SAVE THE SCENIC SANTA RITAS ASSOCIATION

April 7, 2024

Karen Peters, Director
Arizona Department of Environmental Quality
1110 W. Washington Street
Phoenix, AZ 85007

Save the Scenic Santa Ritas (SSSR) and the 13 other organizations listed below herein submit our formal comments on the Draft Aquifer Protection Permit No. P-513690 (APP) for the Copper World Project in Arizona (ADEQ, 2024) and the APP application submitted by Hudbay in 2022 for the Copper World Project. Our comments address issues related to procedures, best practices, water quality, geochemistry, geophysics, and hydrogeology.

Figure 1a: Facility Location from APP Application (2022, Appendix I.10)

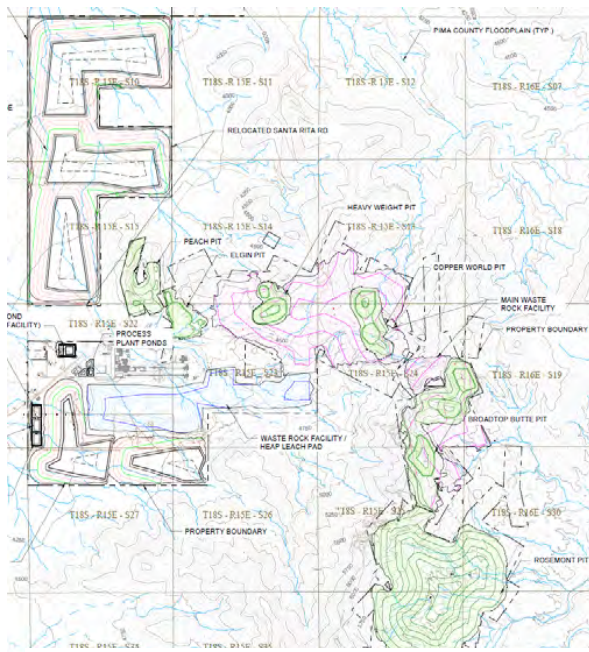
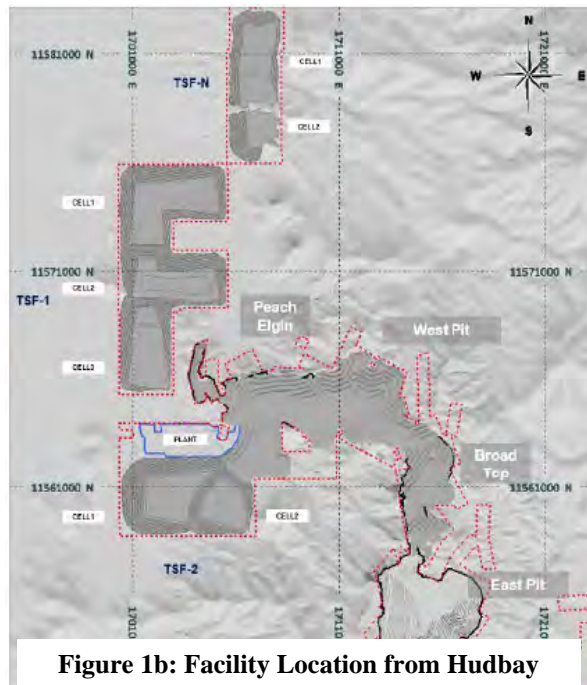
The heap leach pad, which appears in light blue in Figure 1a, is gone from Figure 1b, and has been replaced by expanded TSF-2 cells, and by an expanded waste rock dump. These changes in mine layout footprint affect the potential impacts to groundwater. The heap leach pad was a lined facility, which has been replaced by unlined TSFs, and an increase in the footprint of the Waste Rock Facility.

There is also a new TSF-N, which would also contribute to potential groundwater contamination. There are no details on TSF-N supplied in the 2023 Pre-Feasibility Study. Hudbay has indicated they believe a ‘better option’ to the TSF-N location will show up toward the end the planned mining, but ADEQ is apparently being asked to include this phantom TSF in the APP.

The description of the mine in the APP Application is out of date, and the mine as now proposed by Hudbay (2023) is significantly different from the mine proposed for public comment. The application process should be suspended until an accurate mine description is included in the APP Application.

Figure 49-1, Capture Zone Estimation, Hudbay, August 2022

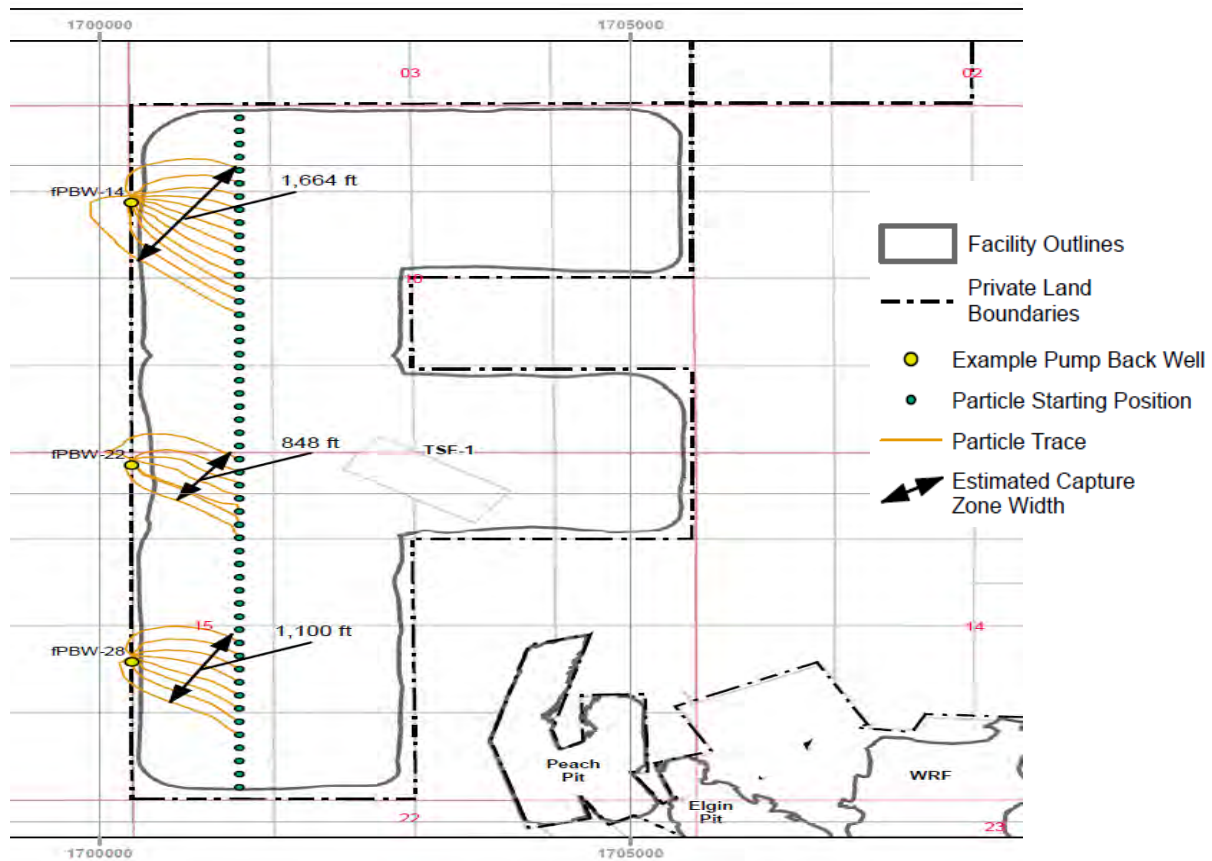
It appears that Hudbay has chosen to use seepage collection wells should the flow of contamination under the dams become a problem (Hudbay 2022, APP-irss Attachment 18, Figure 49-1). Seepage collection wells are the least effective and most costly way to intercept deep seepage flow. For example, seepage under the Fort Knox Mine (Alaska) tailings dam required the installation of two rows of seepage collection wells, because the seepage flow was controlled by fractures that were not intercepted by the first row of wells. Seepage collection wells also pull water from all directions, so excess “clean” groundwater is also typically collected by these wells. Seepage well collection is expensive because of the long-term costs for electricity, and maintaining the pumps and wells.

There is no discussion of grouting or placing a slurry wall to block seepage movement into groundwater. The APP Application relies on the presumed “low permeability” of the sediments underlying the tailings dam to justify removing the BADCT requirement for a tailings impoundment liner. However, as noted in Piteau (2022, Appendix F.1), the assumptions of low permeability and inability of seepage to move under the tailings dams are not substantiated by the technical report documentation.

Figure 1. Proposed point of compliance wells and mine facilities. Blue arrows indicate approximate groundwater flow directions from the Rosemont Pit area, based on flow directions shown in the Draft APP, Figure 35. *Source: Modified from Hudbay, 2022a, Figure 36.*

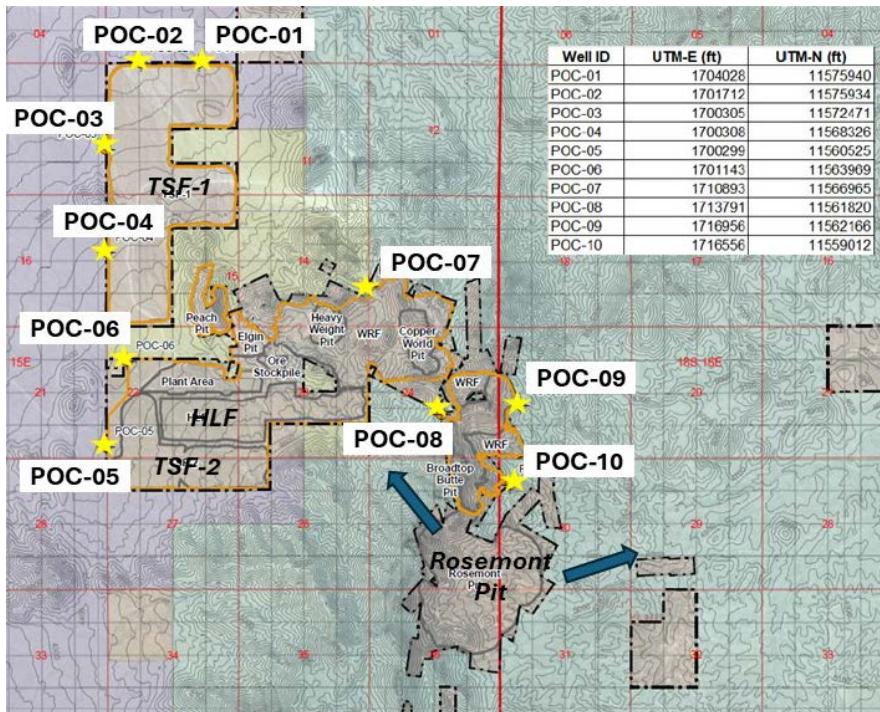
The 10 POC wells proposed by ADEQ (2022) in Figure 36 do not provide adequate coverage for detecting groundwater contamination from the mine site, *especially* considering the newly proposed (Hudbay, 2023) TSF-N and expanded waste rock facility. Davidson Canyon (northeast of the Copper World Pit) is listed by ADEQ as “impaired for Copper” (see Figure 1, [eMaps \(arcgis.com\)](#)). At least one additional POC should be installed on the north boundary of the PMA between POC 7 and POC 9. Three additional POCs should be added east and north of the Rosemont Pit, and three additional POCs should be added to the west/northwest of TSF-1 and

The 10 proposed POC wells are located right on the facility boundaries (see Figure 1). Additional compliance monitoring points, including wells and springs, should be included in downgradient locations between the western mine facilities and the Santa Cruz River and between the Rosemont Pit and Davidson Canyon.

Figure 3. Locations of existing groundwater monitoring wells. The wells sampled are in the same locations as the proposed point of compliance wells (refer to Figure 1).

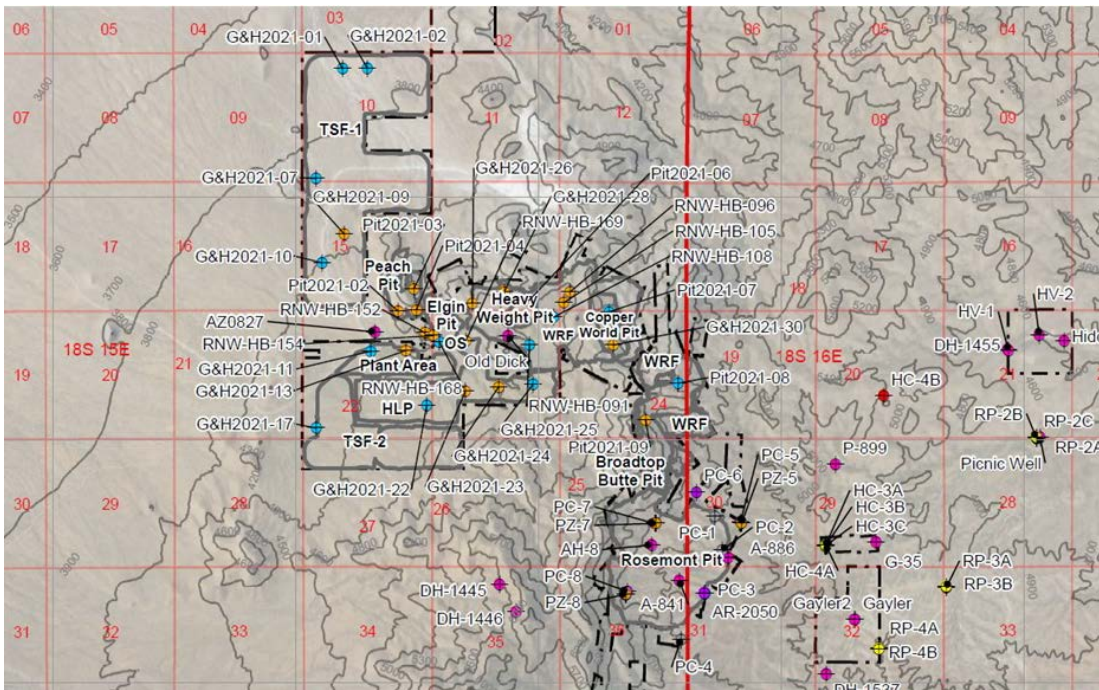
As shown in Figure 3, the existing groundwater monitoring wells are in the same areas as the proposed mine facilities and POCs. Because none of the wells exceeded AWQS values in ambient/baseline water quality and the wells are in similar locations, ADEQ could include temporary AQL and AL values in the Final APP for at least all parameters with AWQS values until sampling of the 10 POC wells is completed. This approach would provide more certainty than entering “reserve” in Table 19 of the Draft APP and would provide protection during mine construction.

FIGURE 16-7: SECTION A-A' – EAST PIT MINE PHASES

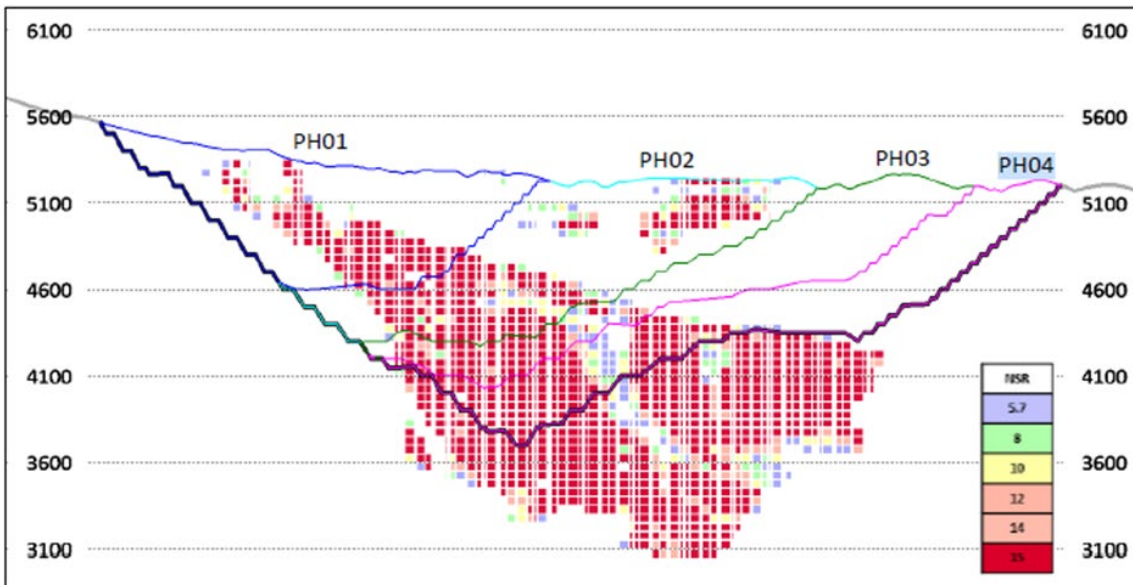
2. Pima County believes that it is intentionally and inappropriately misleading to say this is a permit for a 15-year project, when the actual term of the permit is valid until suspended or revoked by ADEQ. The entire Copper World project has an extended 30+ year Phase 2 to begin once Hudbay can acquire the necessary federal permits that have so far impeded their progress towards permitting of the original Rosemont Copper project. While a two-phased

approach was presented in the 2022 Preliminary Economic Analysis (PEA), their 2023 PFS claims that Hudbay has redesigned their plan into a single 20-year plan with four smaller phases. However, the APP application discusses a mine life of 15 years, indicating that their plan is once again for this Phase 1 and Phase 2 as presented in the PEA. The figure below is from Section 16.2.3.2 of the PFS and although Hudbay claims that the bold purple line represents their final phase of their 20-year mine life, it is clear and obvious that they are simply positioning the pit to go back and process the remaining ore body as modeled by red. It is difficult to believe that Hudbay will do all this work, construct these facilities, and then leave the remaining ore body unmined. As mentioned earlier, the only reason they cannot do it from the beginning is because their resultant pit would be too wide and the extra waste would need to be deposited onto federal lands. The private lands they currently hold are not large enough for the waste material. In granting the permit, ADEQ should acknowledge to the public that this permit, as amended, could be active for at least 45 years.

3. Pima County requests the addition of the East Pit as an APP-regulated facility under the Copper World permit. ADEQ is obligated to evaluate whether or not the East pit is a discharging facility under A.R.S. §49-241.A. It is claimed in the application and supported by studies that the Rosemont Pit will eventually become a hydraulic sink, and is therefore not a discharging facility. However, this behavior of hydraulic sink will take time to establish. During initial pit construction and operation, the pit may not act as a hydraulic sink. The applicant has not demonstrated that the discharged pollutants will be captured and hydrologically isolated in the depressed water table around the pit at early timeframes. Additionally, the use of the dewatering volume used to maintain the hydraulic sink during closure and post-closure have not been addressed.

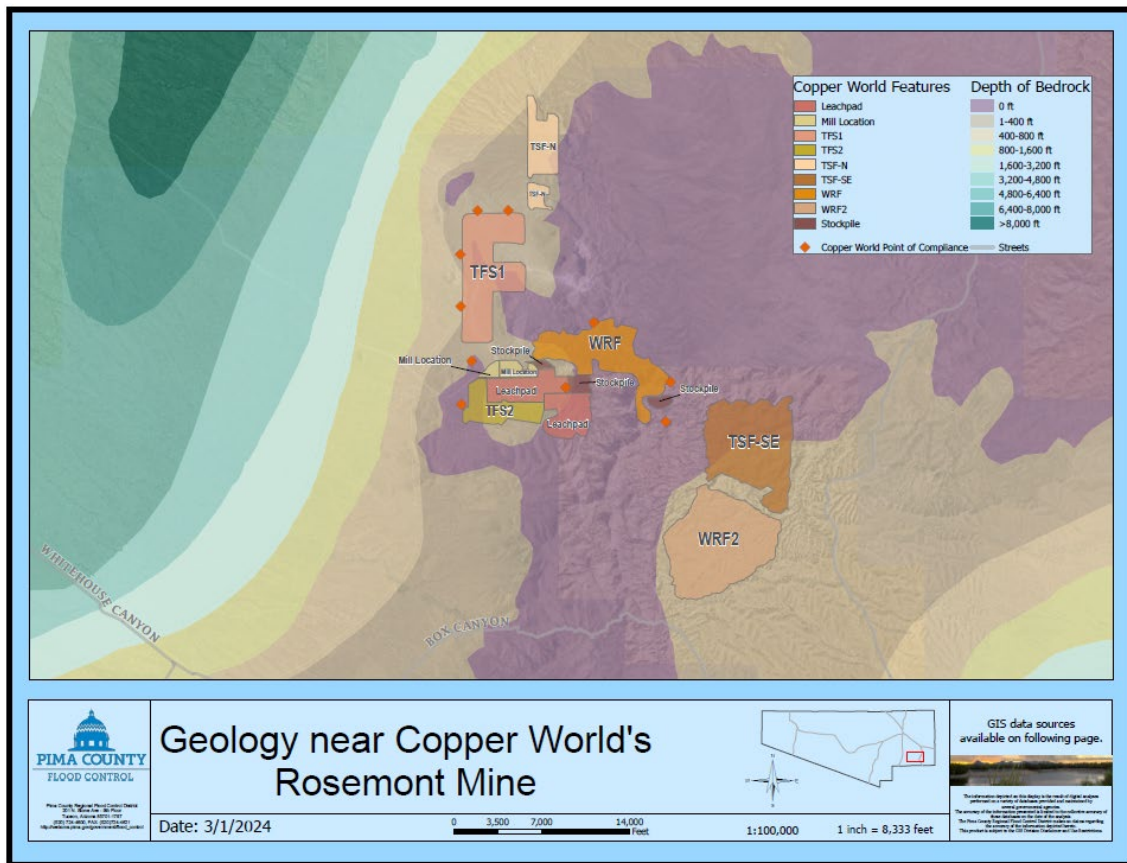
The figure below provided by Pima County Regional Flood Control District shows the depth to bedrock. There is a large drop off in the bed rock which goes to 400-800 feet. This demonstrates the varied site conditions and the possibility for leakage through the bedrock and directly into the aquifer. The site-specific conditions given in the draft permit are inappropriate and are inadequate in managing pollution in the TSFs.

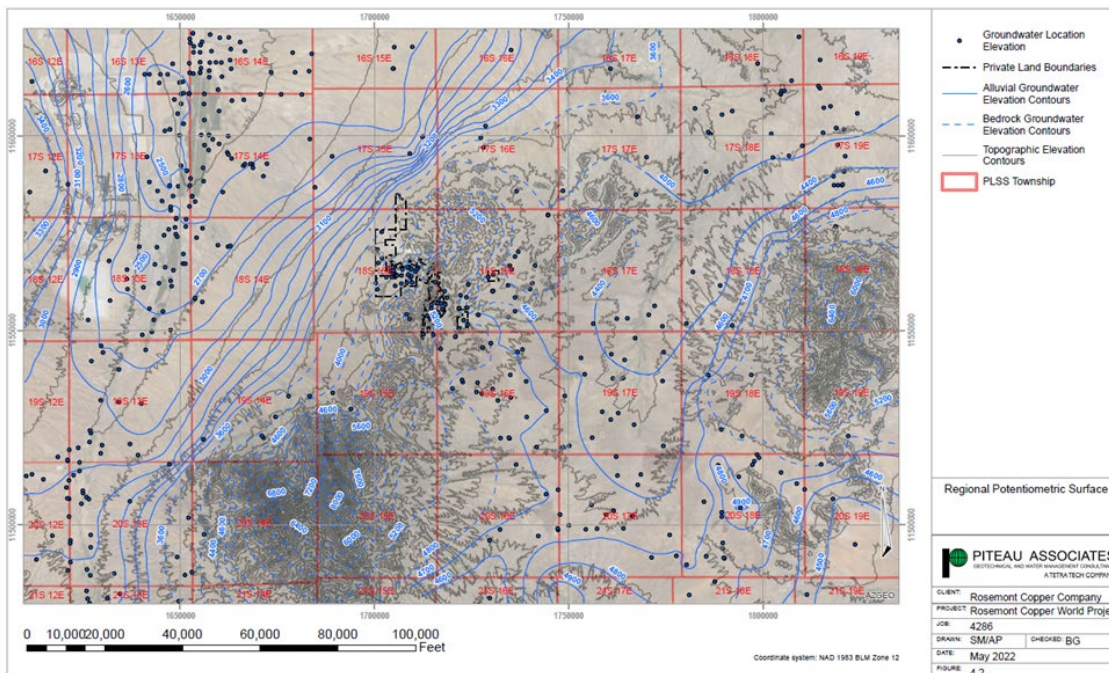
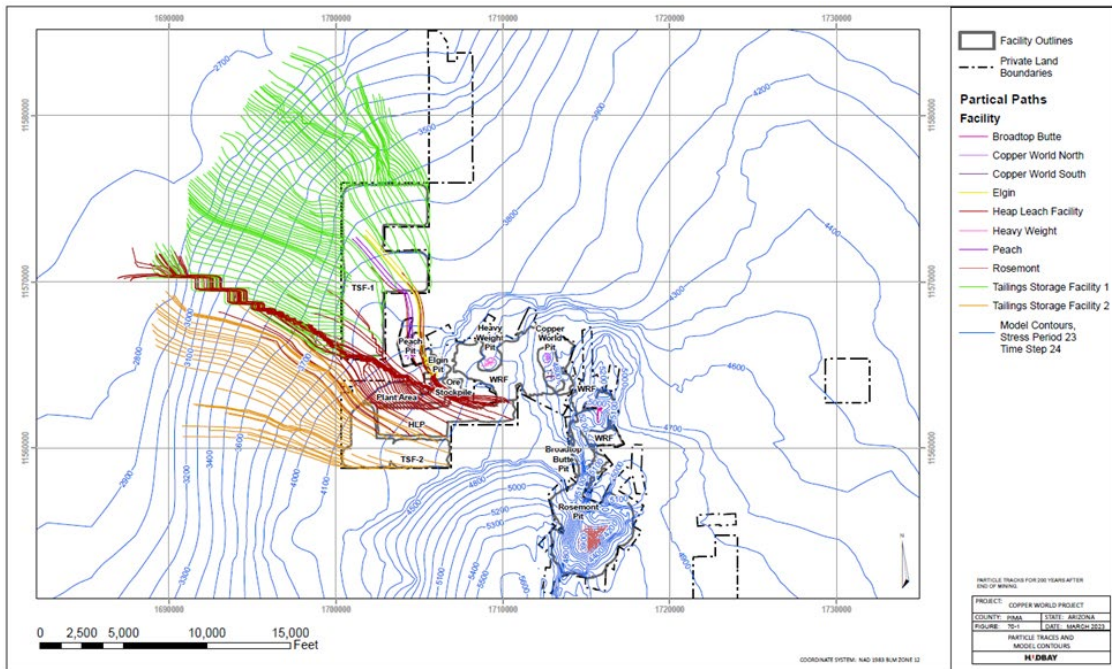
The particle traces and groundwater model contours as displayed in Figure 70-1 (below) from Attachment 31 of Hudbay's response to ADEQ's initial RAI is useful in demonstrating the hydraulic gradient and the mobility of pollutants discharged at certain points within the PMA. Not only does this figure demonstrate a clear hydraulic gradient to the northwest of the TSFs with the blue contour lines, but it also confirms via the particle traces (in red and green) that there is significant pollutant mobility for the TSFs and the HLP. The hydraulic gradient is again confirmed by Figure 4.2 (below) of Appendix F.1.

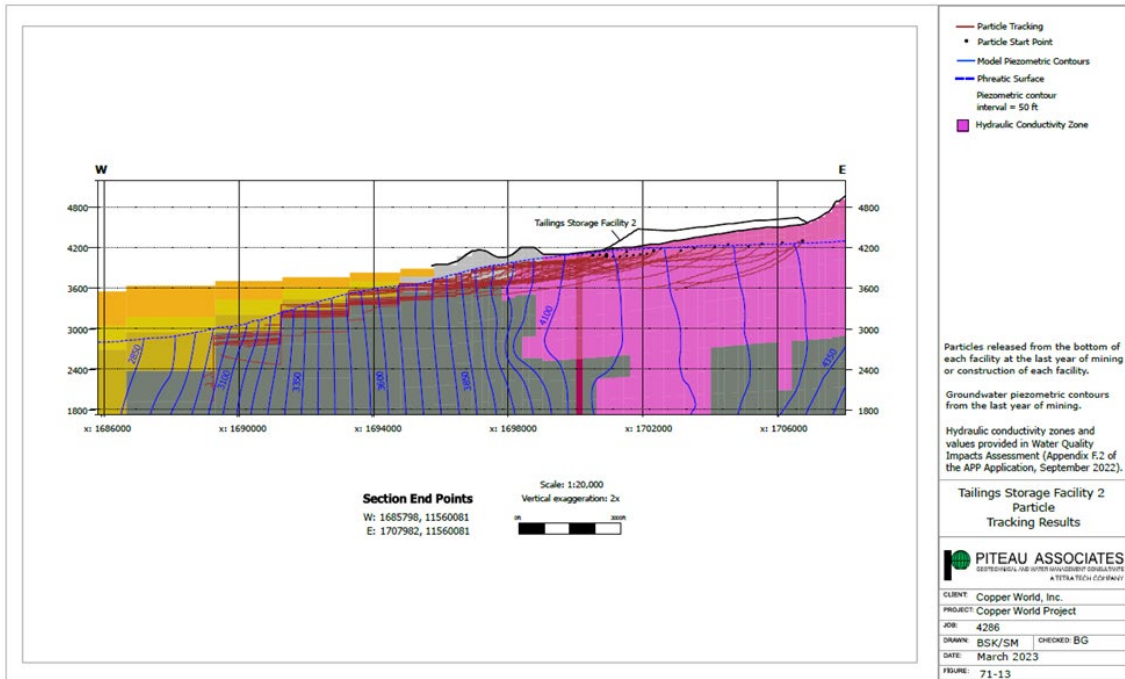
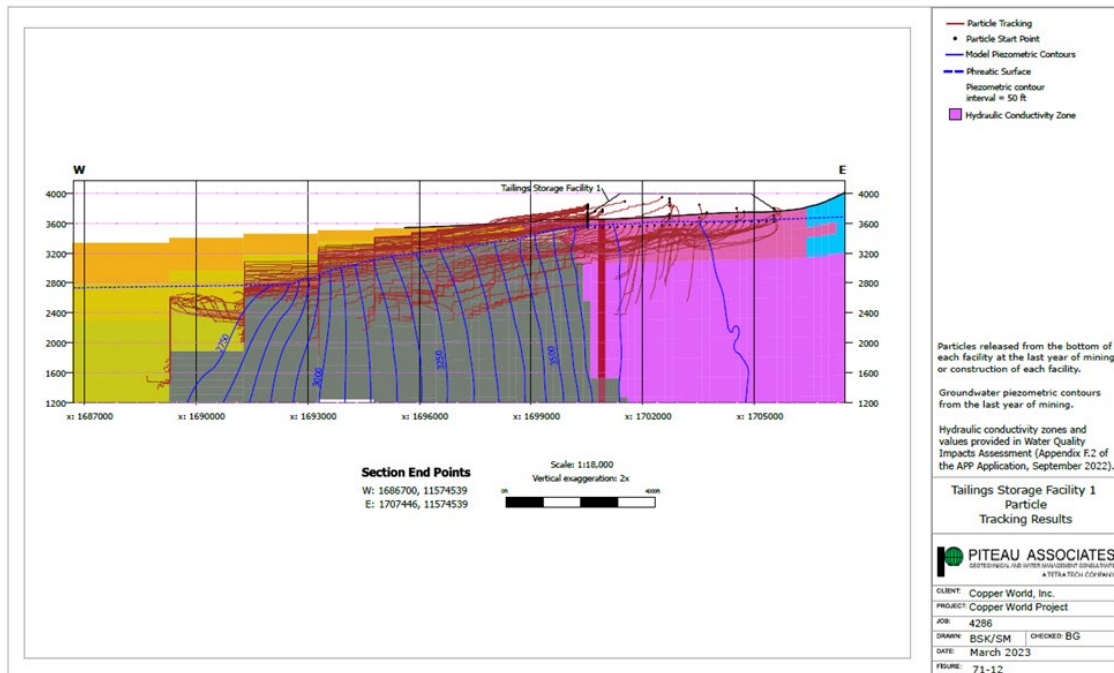
Additionally, Figures 71-12 and 71-13 (below) from Attachment 32 to Hubbay's response to ADEQ's initial RAI show the cross-sectional particle traces for TSF-1 and TSF-2, respectively, and further demonstrate the high mobility of pollutants downward and laterally. In the traces

below, the model shows pollutants moving down and through the alluvium unit towards the Tucson Basin aquifer. The dashed line in these documents is the phreatic surface, and it represents the depth to water. When a particle tracking line has passed below the phreatic surface, it has effectively entered the aquifer. This should be no surprise, as it was previously stated that the depth to water above the TSFs is only 20 to 48 feet. It can be seen that particle tracing lines nearly immediately cross the phreatic surface, and thus nearly immediately enter the aquifer. Another potential direction of movement would be in the alluvium just above the bedrock contact until it reaches the adjacent basin fill units. The model did not represent thin alluvial unit which underlies the TSFs, which eliminated any consideration of this potential.
